## Landoff Angel Lane, Stratford

planning application no. 19/00097/FUL

### Strategic planning application stage 1 referral

**Image 2: Pedestrian access and movements**

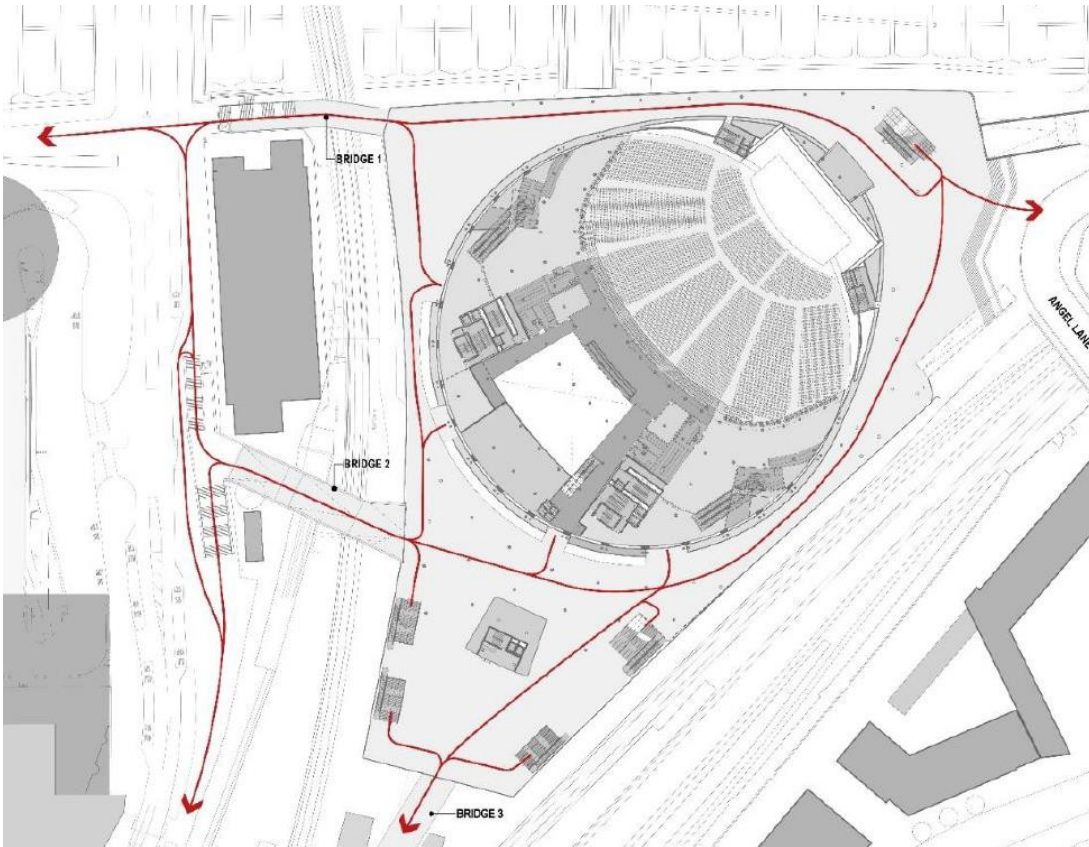
69 The proposal would improve pedestrian permeability within the surrounding area, provided that the pedestrian routes are available 24/7. Notwithstanding this and as detailed elsewhere in this report, further details are required to demonstrate how the capacity of the development would be capped and the likely occurrence of full-capacity events. GLA officers must be satisfied that size of public realm and width of access routes along the three pedestrian bridge links and Angel Road access can safely manage anticipated pedestrian flows. Consideration is also required in terms of the acoustic impacts of the crowds on surrounding residential properties.

Figure 1 Cumulative Mean Densities at Key Locations within the station (1845-1900)

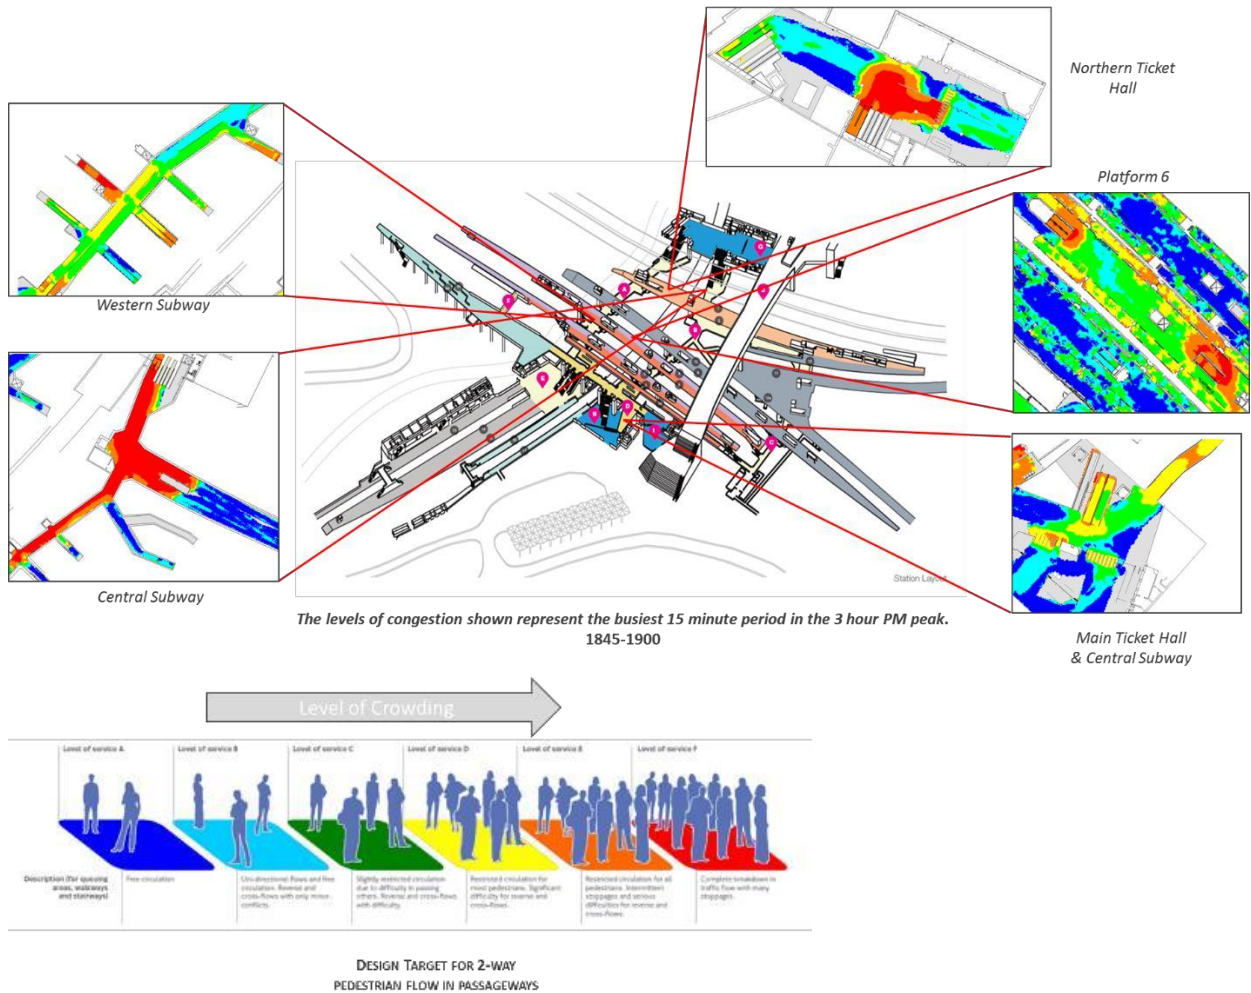
This translates into the following diagram, which shows the Fruin Level of Service in key locations within the station assessed under the assumption of the ‘closing’ of the ticket gates.

As you can see from the table above, the proposed development results in a significant uplift in the use of the Northern Ticket Hall and the Central and Eastern subway. This will result in significant queuing on the central subway, stairs/escalators and in the Northern Ticket Hall, which presents significant safety concerns and concerns regarding the operation of the station.
